STATE OF VERMONT
AGENCY OF TRANSPORTATION

PROPOSED IMPROVEMENT
BRIDGE PROJECT

ROUTE NO: TH 18 CLASS 3 BRIDGE NO: 17

RECORD PLANS

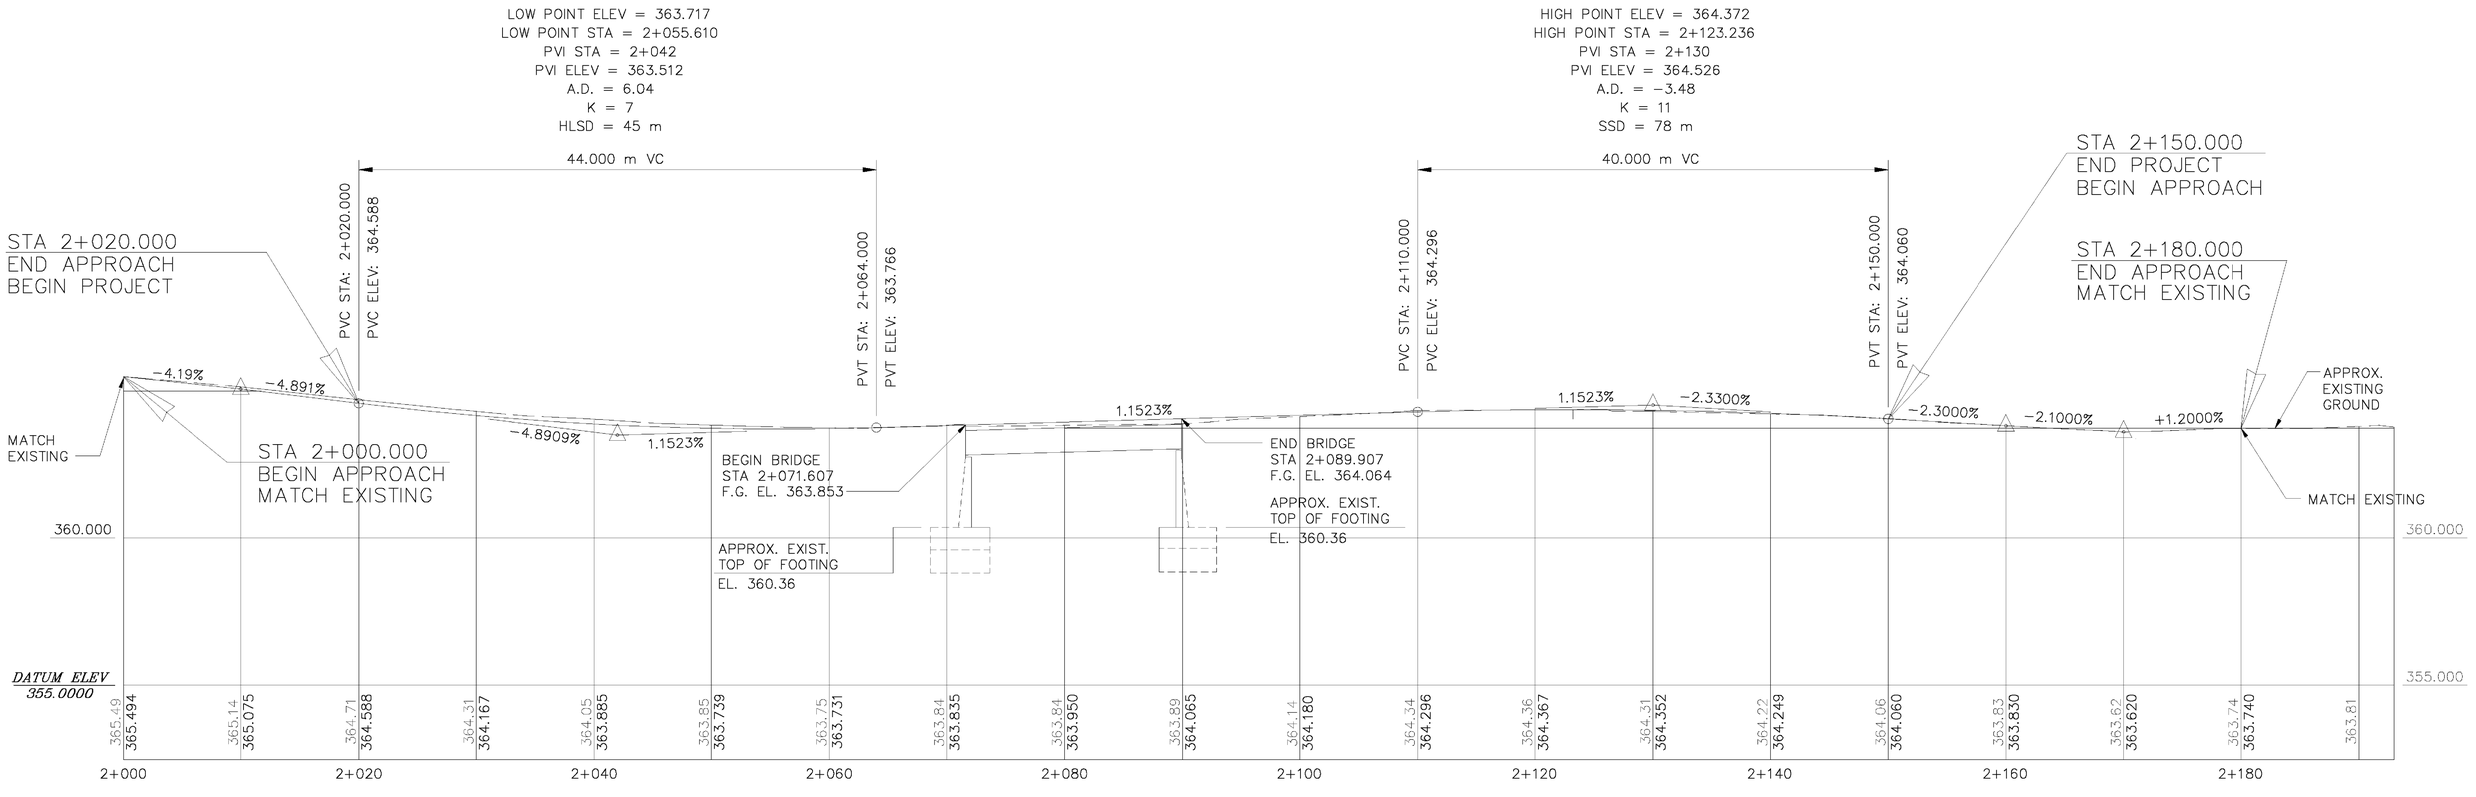
REVISED BEGIN APPROACH GRADE AND EXISTING ELEVATIONS.

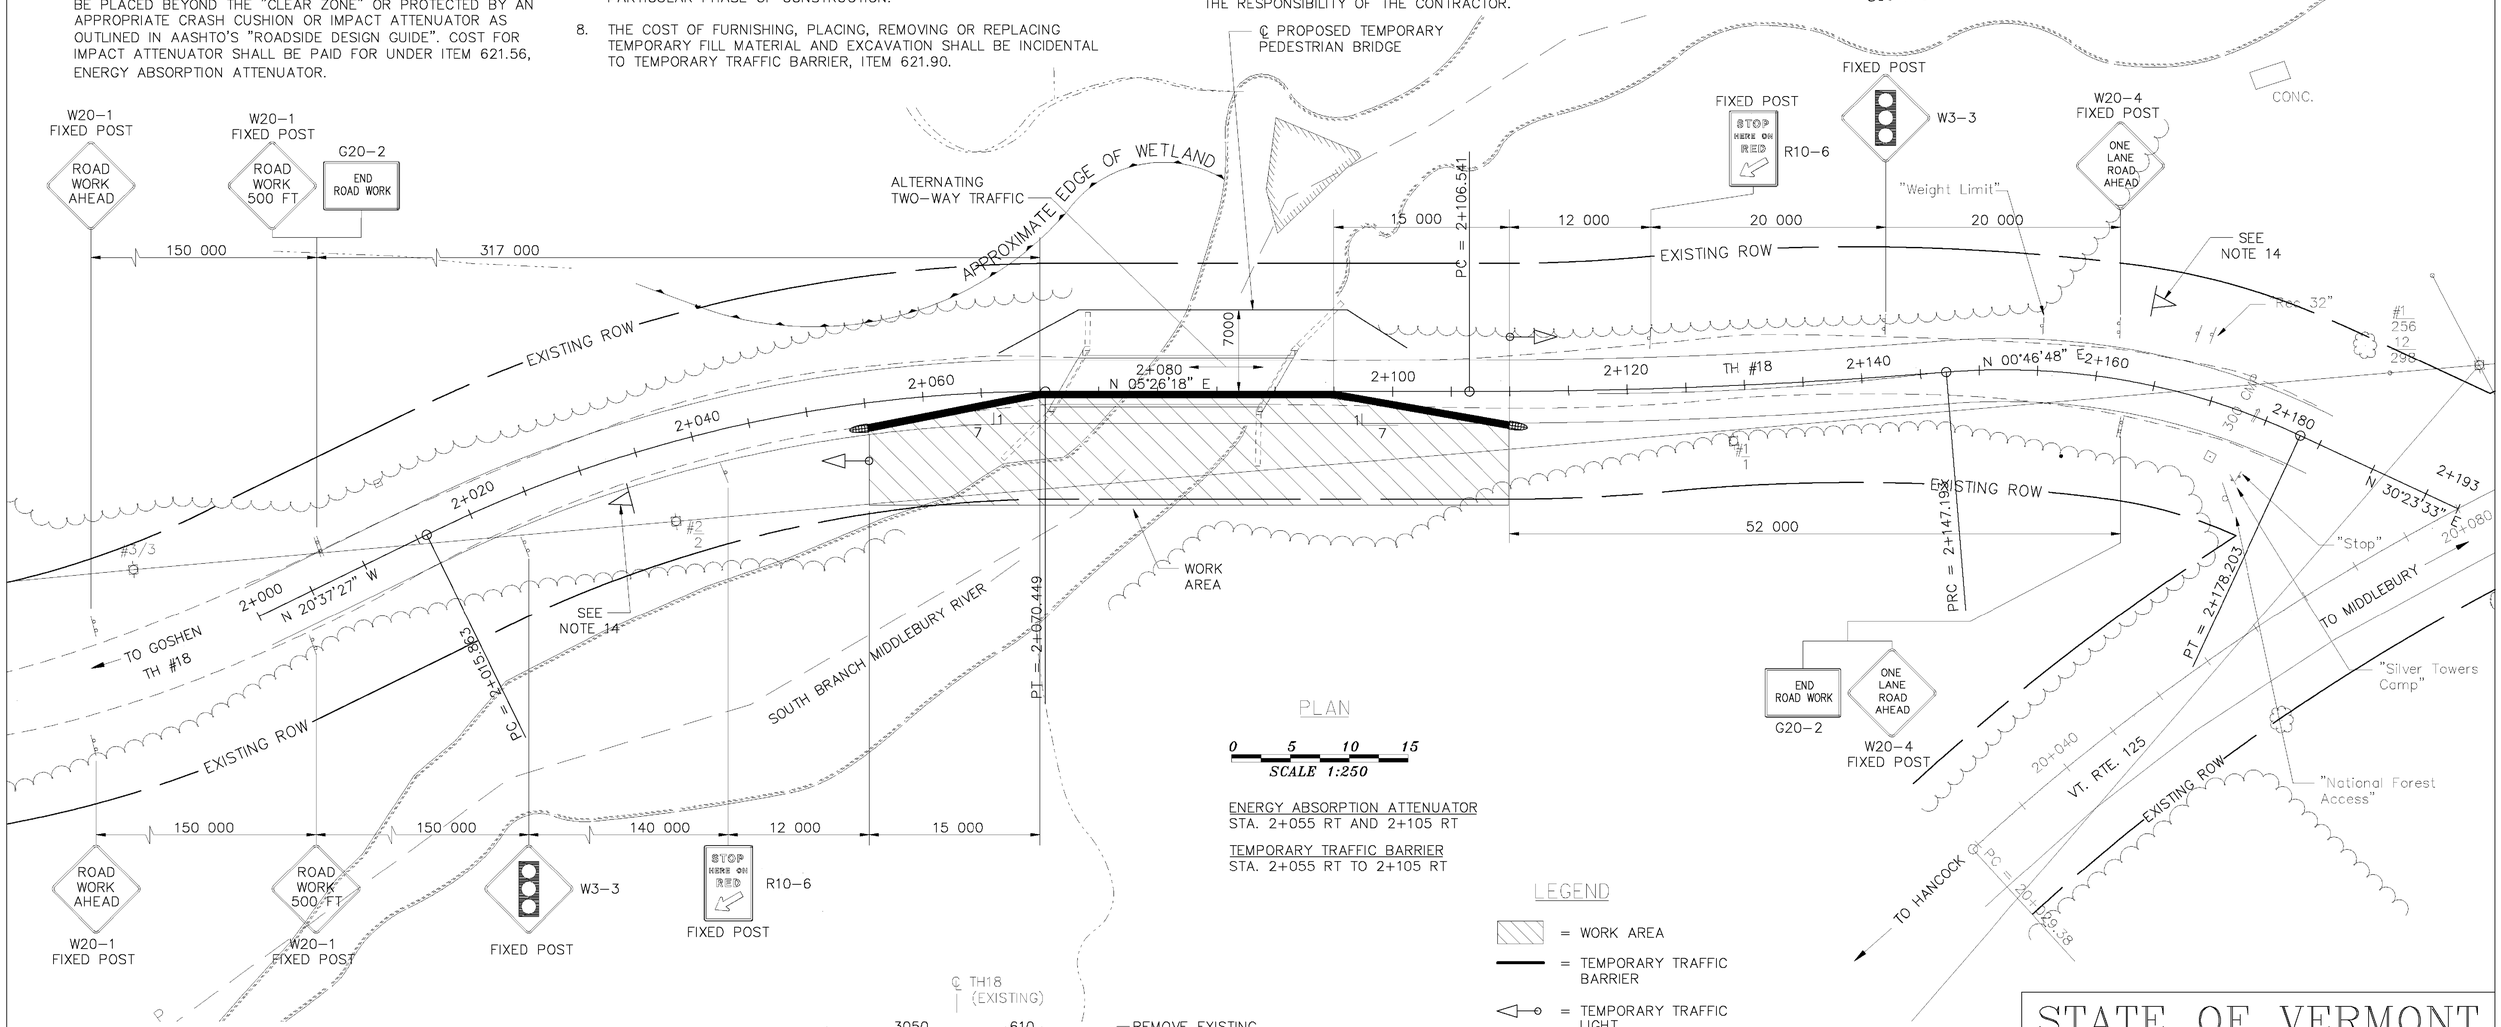
REVISED WEST EDGE OF RIVER LINE.

Designed By B P GUZAS	Drawn By W J GAYNOR
Checked By Y I LIU — Date 8/09	Bridge Design Supervisor R L JOY — Date 10/09
PROJECT RIPTON	PROJECT NO. FH 010–1(2)
I.G.C. Info.	
Bridge Sheet No.	Sheet 12R of 26

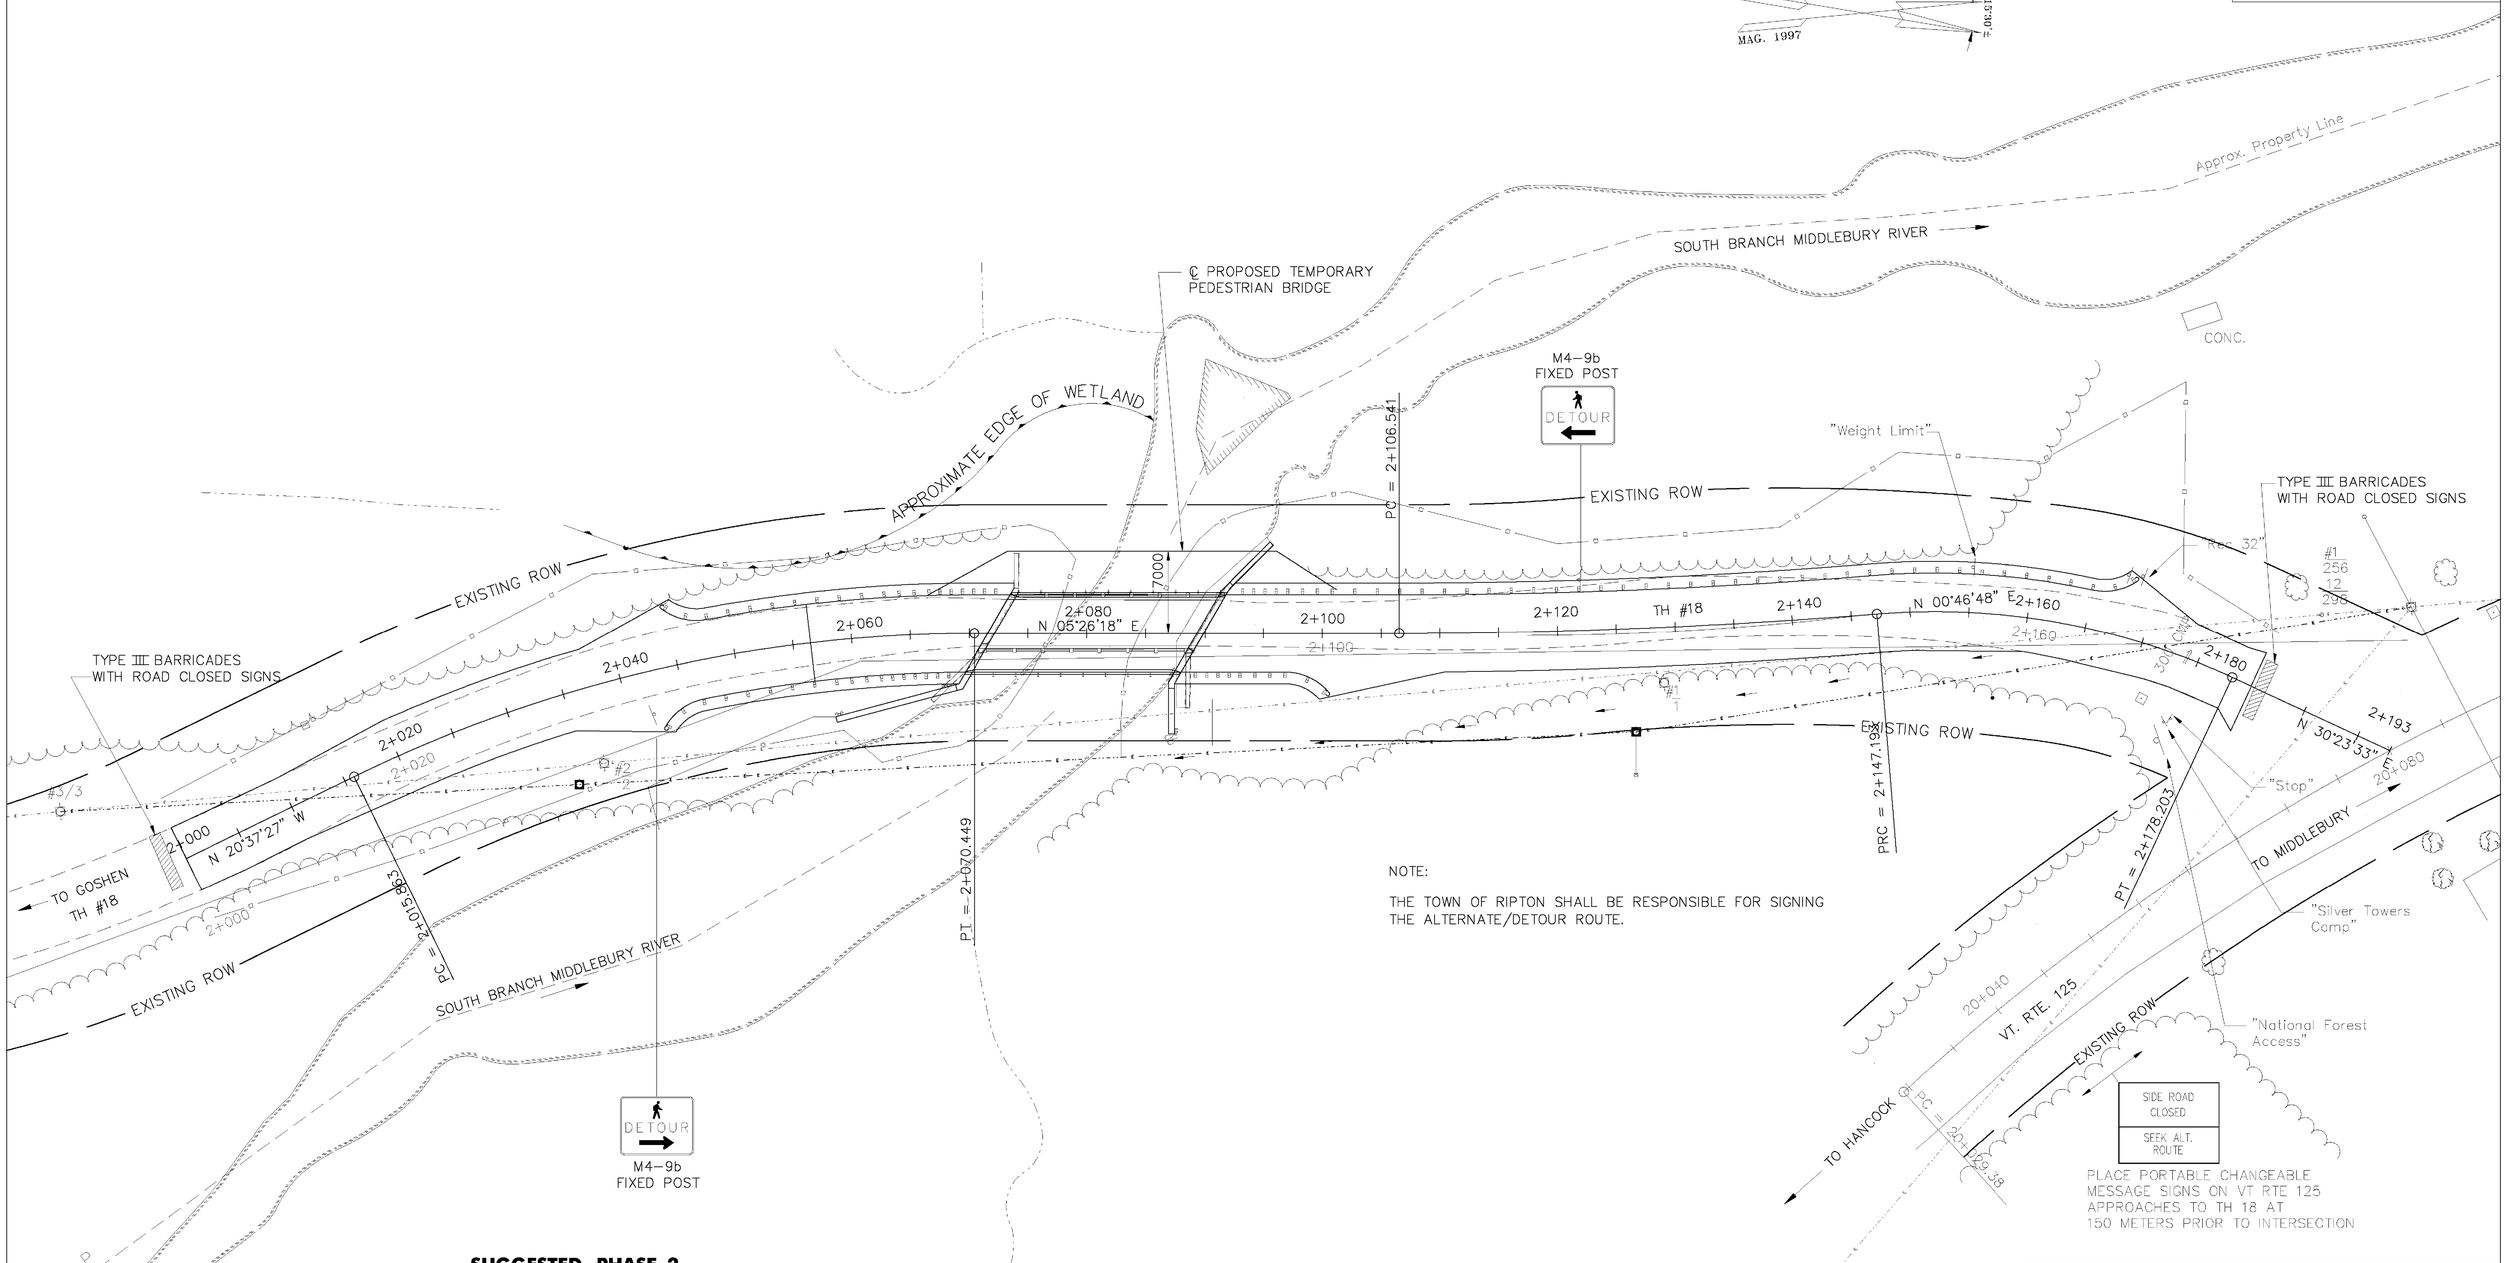
REVISED WEST EDGE OF RIVER LINE.
REVISED WINGWALL 2.

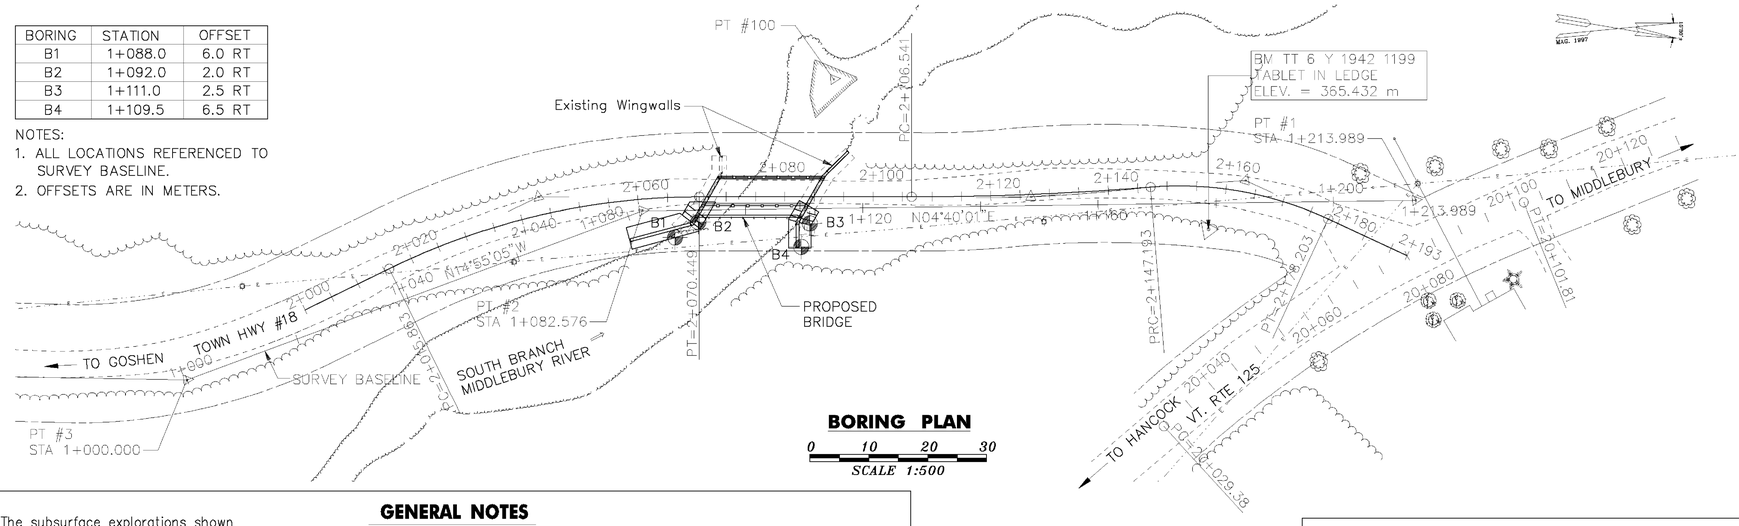
REVISED WEST EDGE OF RIVER LINE.
REVISED WINGWALL 2

PLAN

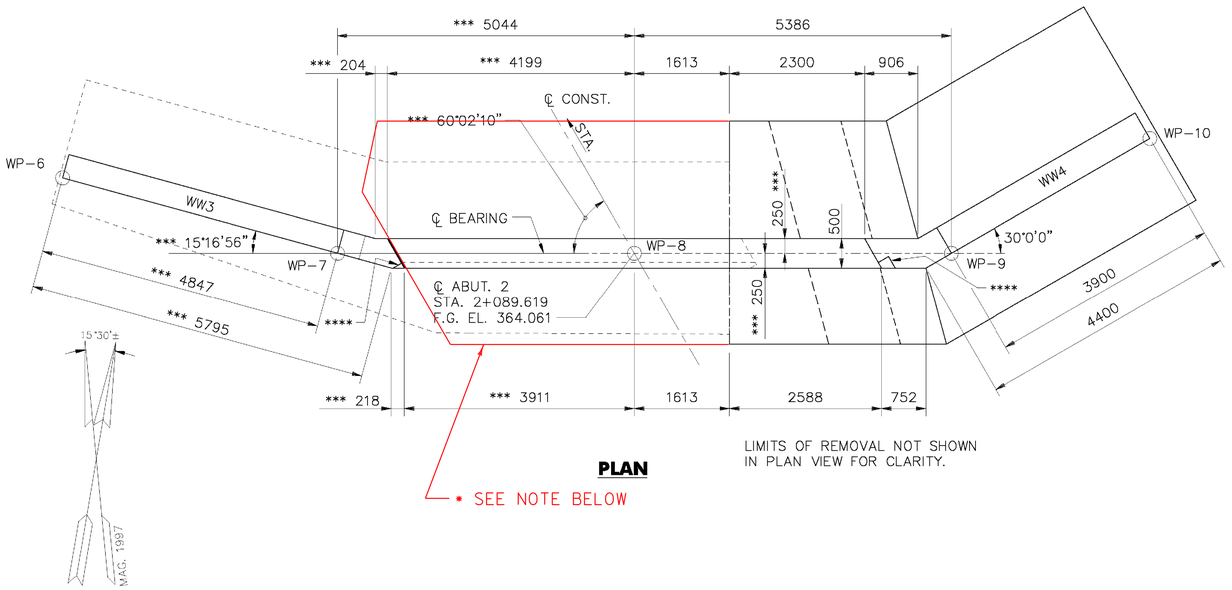
* WW #3 WORK DEEMED UNNECESSARY

Designed By Y I LIU	Drawn By W J GAYNOR
Checked By B P GUZAS Date 8/09	Bridge Design Supervisor R L JOY Date 10/09
PROJECT RIPTON	PROJECT NO. FH 010–1(2)
I.G.C. Info.	
Bridge Sheet No.	Sheet 19R of 26

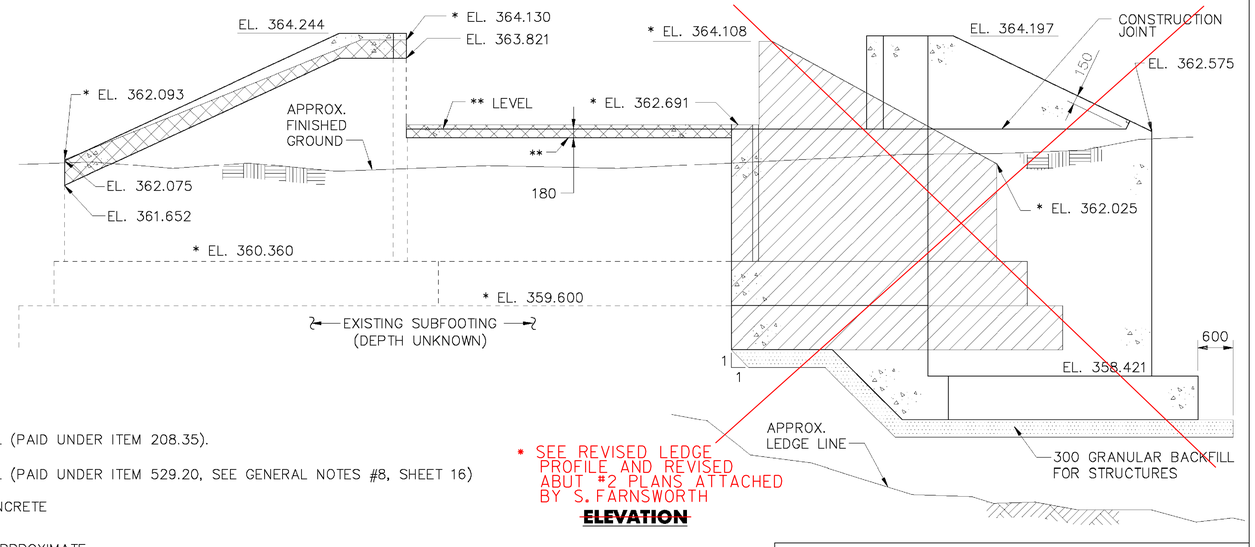
* SEE REVISED LEDGE PROFILE AND REVISED ABUT #2 PLANS ATTACHED BY S. FARNSWORTH

Designed By W J GAYNOR	Drawn By W J GAYNOR
Checked By Y I LIU Date 8/09	Bridge Design Supervisor R L JOY Date 10/09
PROJECT RIPTON	PROJECT NO. FH 010-1(2)
I.G.C. Info.	
Bridge Sheet No.	Sheet 22R of 26

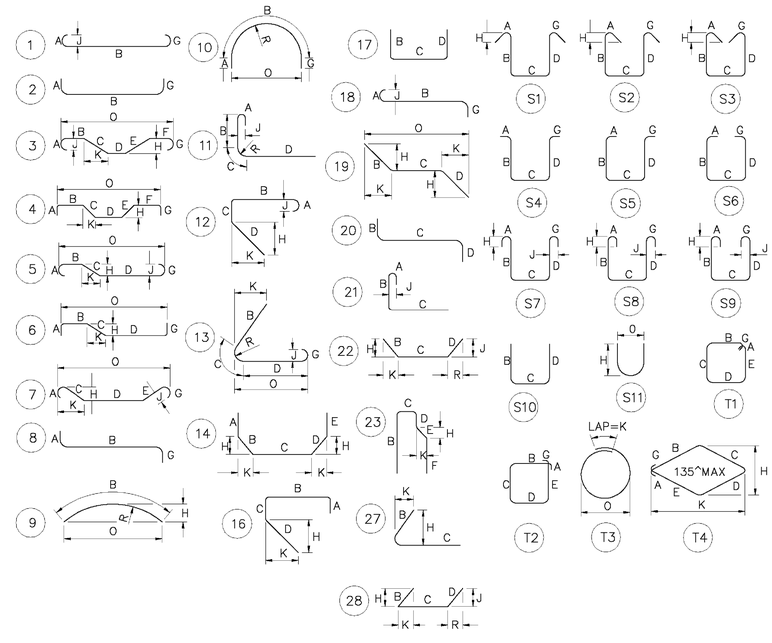
REVISED WINGWALL 2.
